**Feasibility Study
for the Groundwater Operable Unit
at Paducah Gaseous Diffusion Plant
Paducah, Kentucky**

Volume 1. Main Text

Subject: 1) Transmittal of the *Feasibility Study (FS) for the Groundwater Operable Unit at the Paducah Gaseous Diffusion Plant, Paducah, Kentucky* (DOE/OR/07-1857&D2) Primary Document

Subject: 2) Comments on the Internal Draft Revised Feasibility Study for the Groundwater Operable Unit at the Paducah Gaseous Diffusion Plant, Paducah, Kentucky (DOE/OR/07-1857&D-Internal Draft)

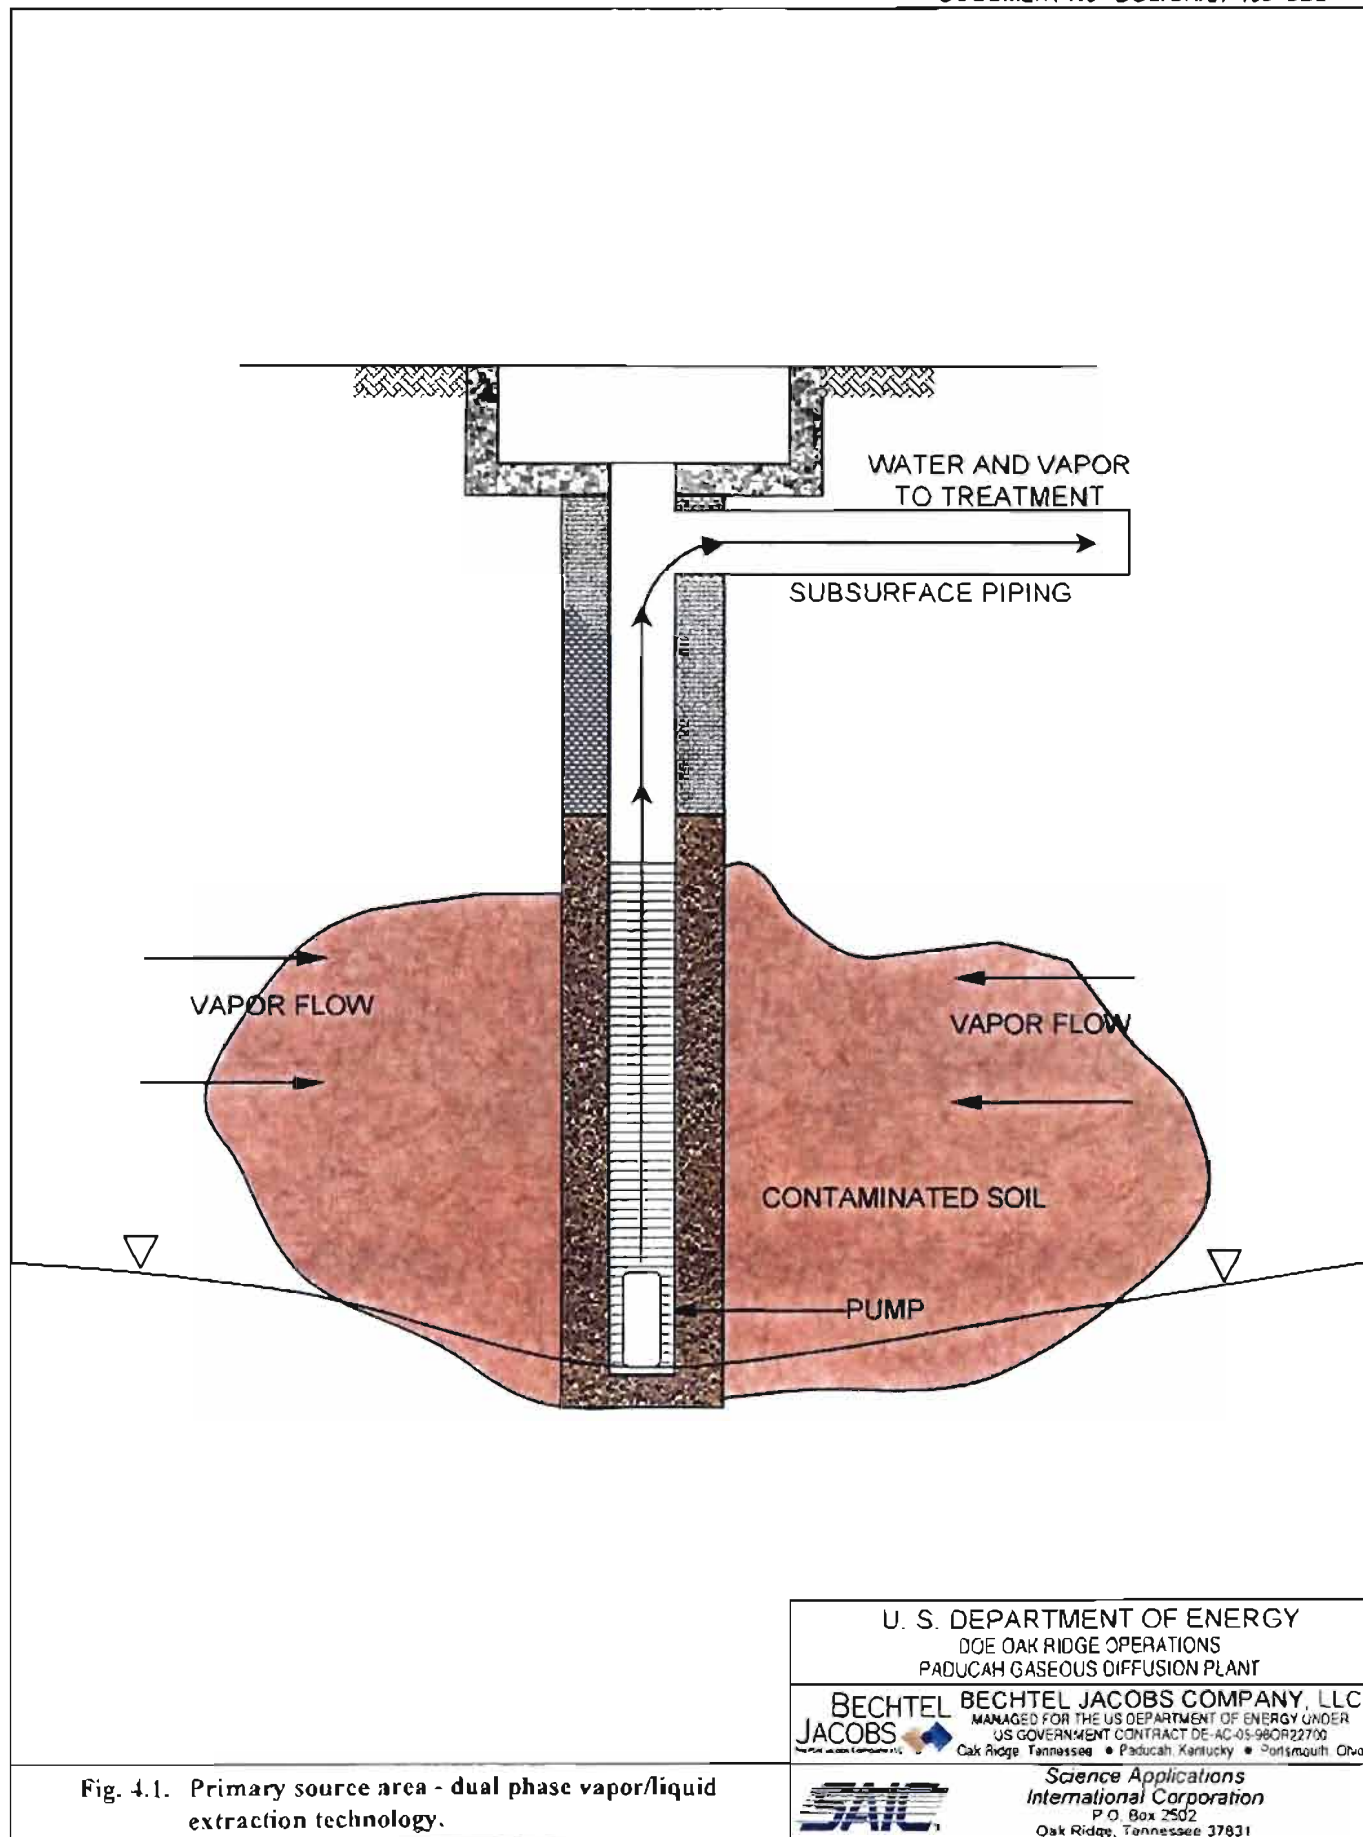
75.	Figure 4-1	NRE/B. Robinson: "Soil vapor symbol looks like water. Could you change this texture?"	Agree.

Fig. 4.5. Secondary source area - pump and treat technology.

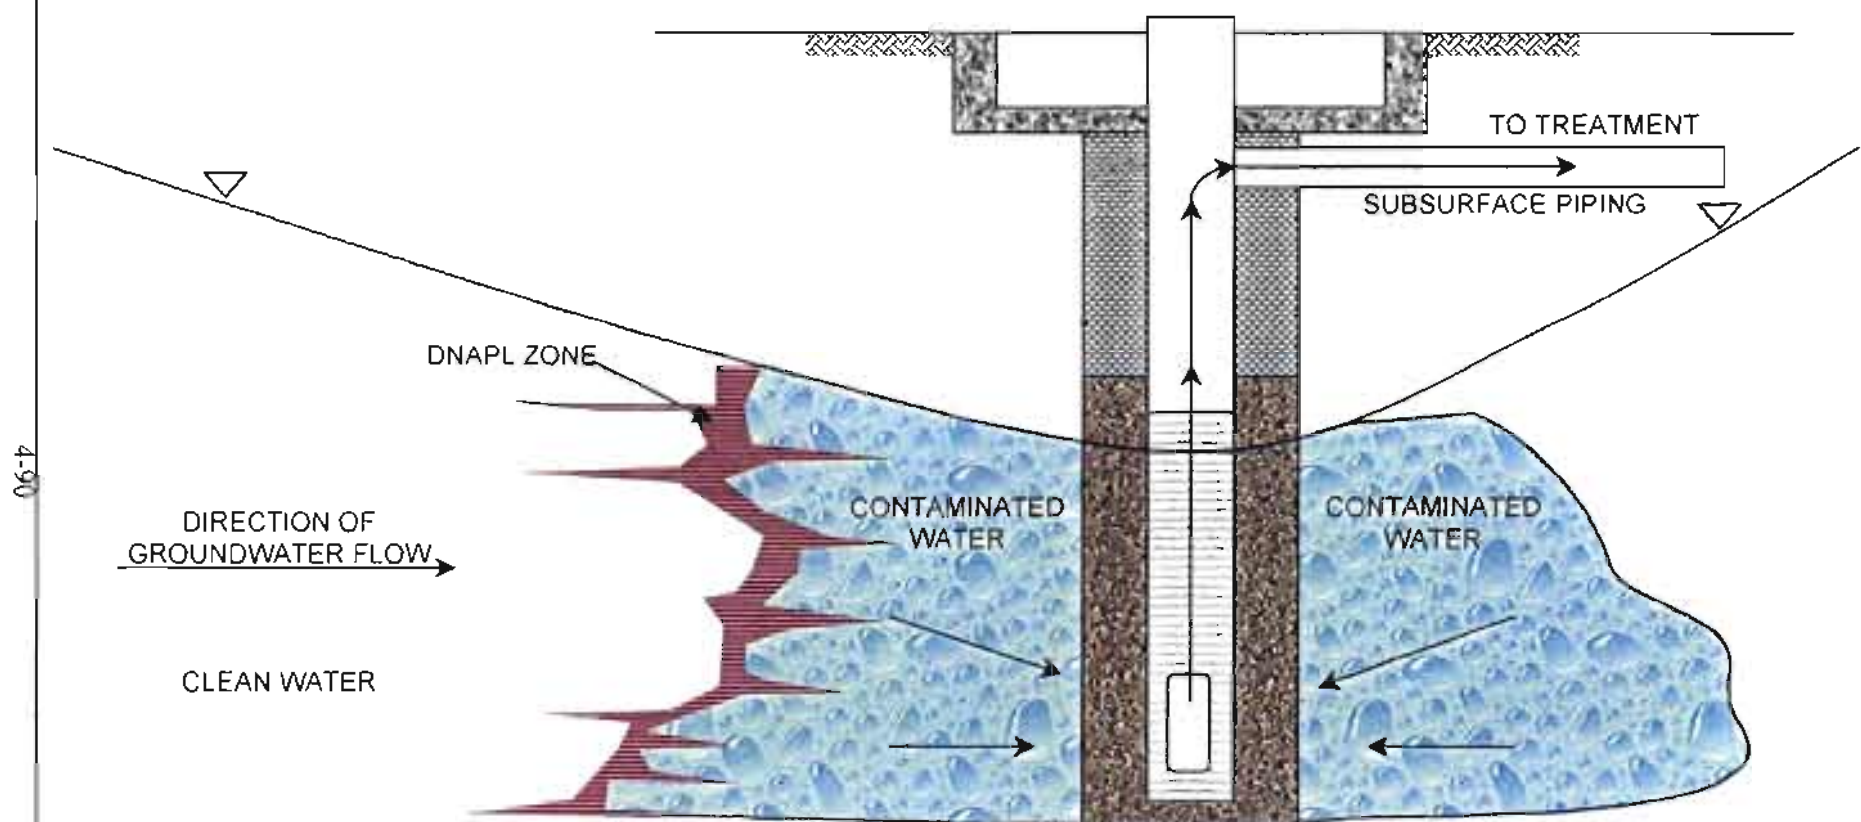
Comment Number	Sect. Page/Para.	Reviewer and Comment	Response
86.	Figure 4.5	<p>NRE/B. Robinson:</p> <p>"In general, how many extraction wells, how large an area, and how much water to be treated?"</p>	<p>The application of the alternatives to specific areas and the development of the details to implement the technology in those areas are beyond the scope of this FS. This FS does not select the specific areas in which the technologies will be applied. These details will be developed and documented in any decision documents that are created.</p> <p>This comment did not result in a modification of the text.</p>

Fig. 4.9. Dissolved phase plume area - permeable treatment zone technology.

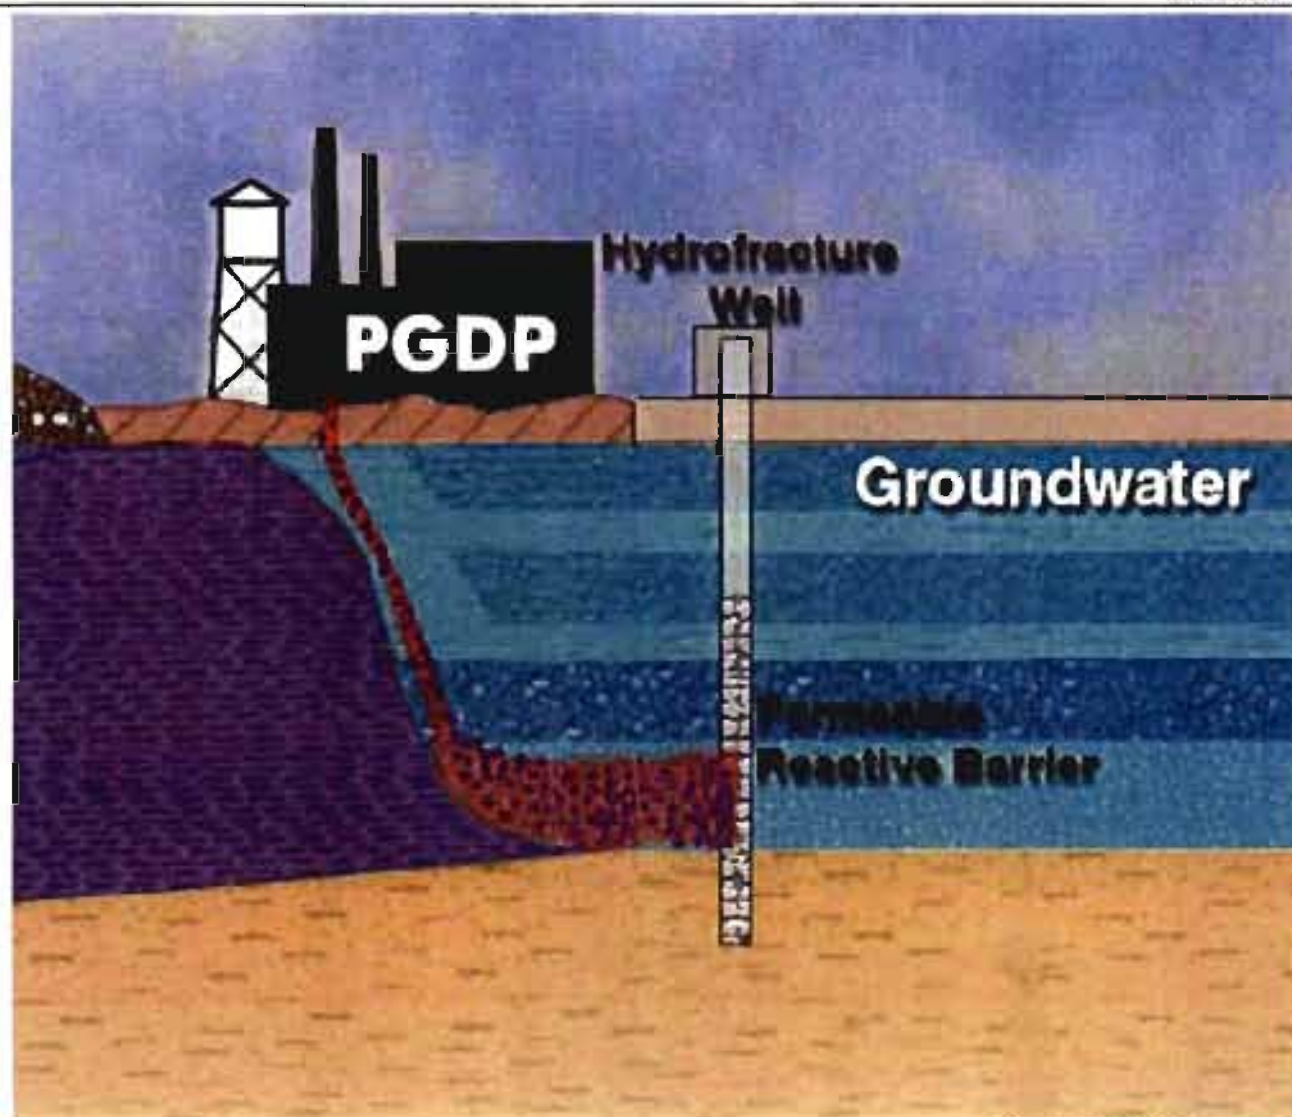
91.	Fig. 4.9	NRE/B. Robinson: "This and other figures are a bit Spartan. Could use a little more detail, labeling, etc."	Disagree. Please refer to Comment #10. The text was not changed as a result of this paragraph.

Fig. 4.10. Reductive dechlorination pathway of TCE.

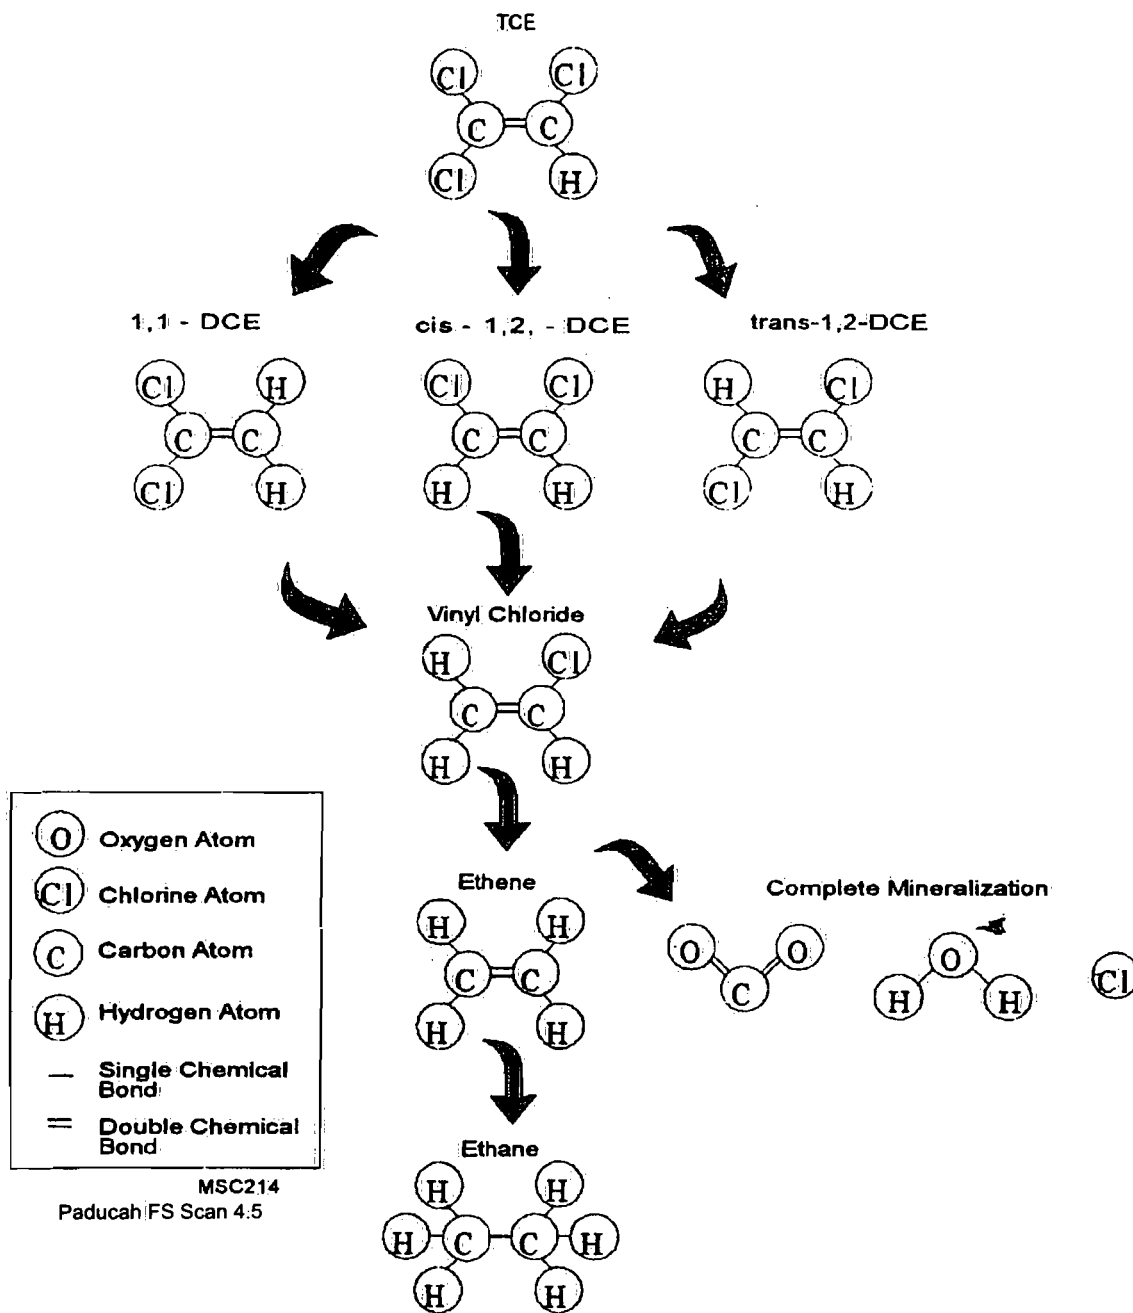
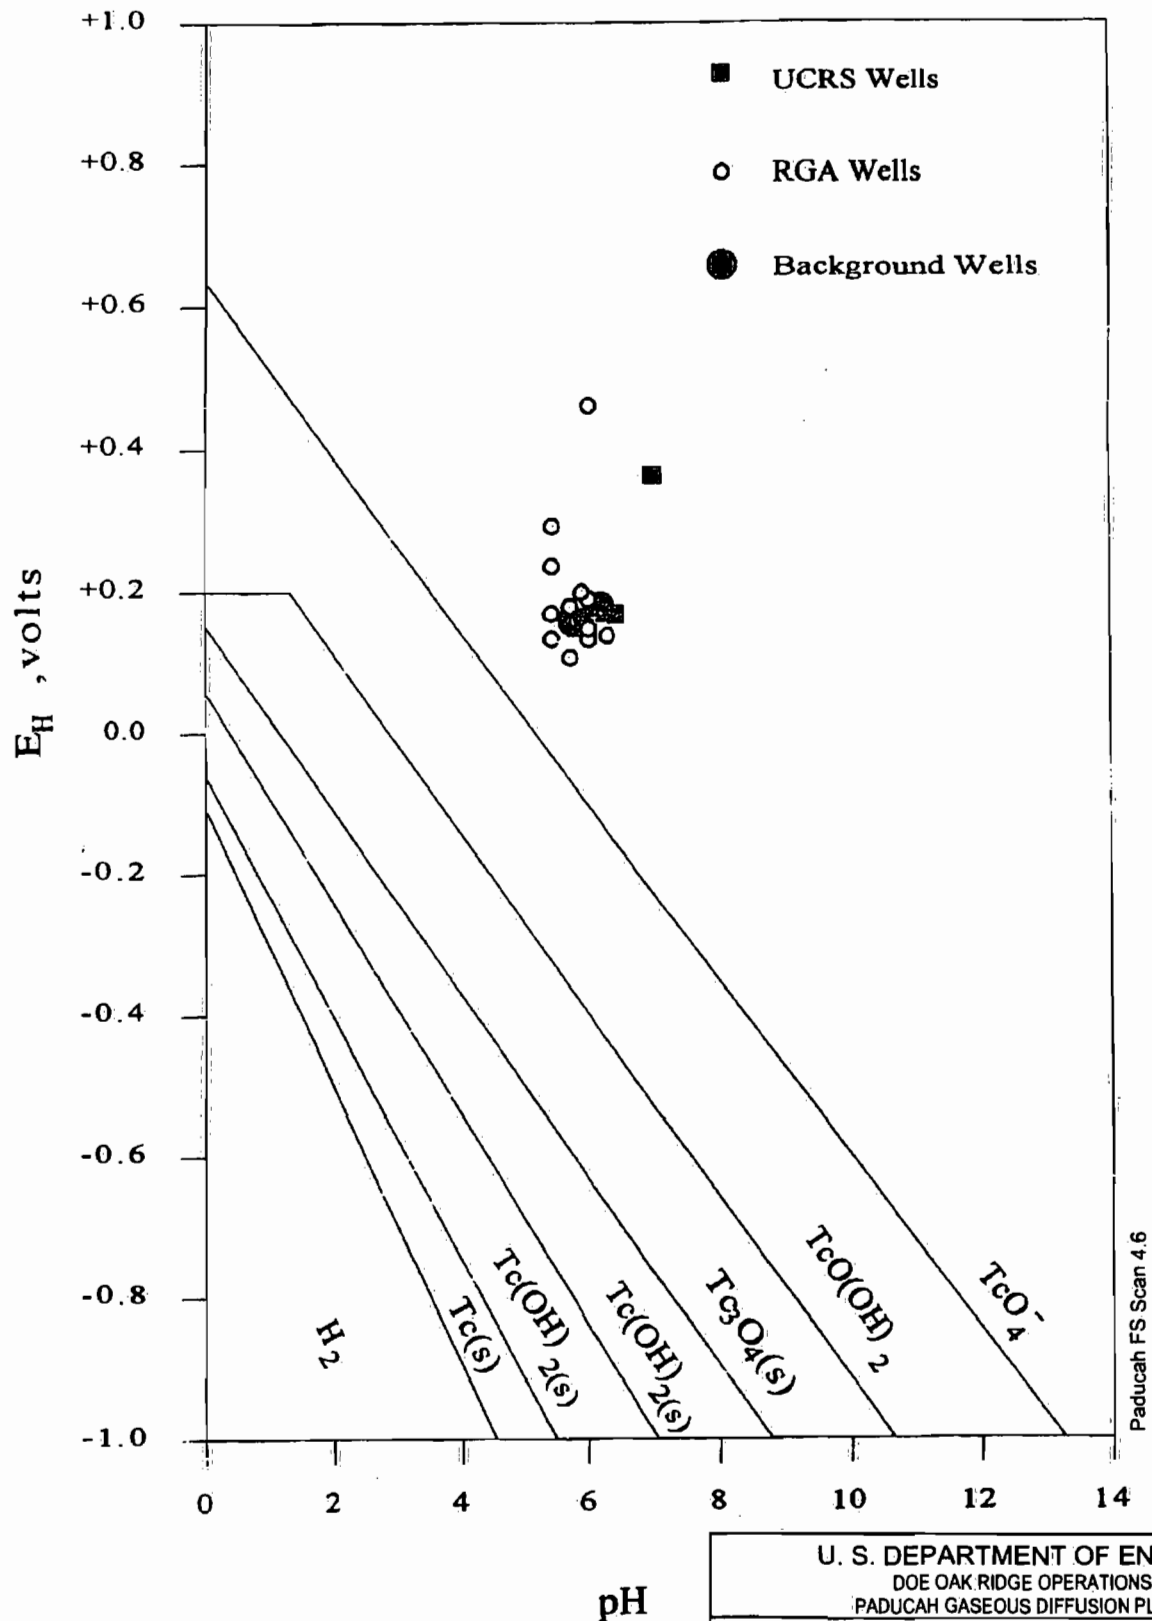
Comment Number	Sect. Page/Para.	Reviewer and Comment	Response
92.	Fig. 4.10 and 4.11	NRE/B. Robinson: "Eliminate Figures 4.10 and 4.11 and rewrite this paragraph."	Disagree. The figures and the paragraph assist in explaining the level of understanding as to why the technology works. Due to the passive nature of this technology it lends itself to the question, how can this work? How can just putting iron in the ground work? To that end, the figures will remain. Also, they have been used in the previous FS with no concern.
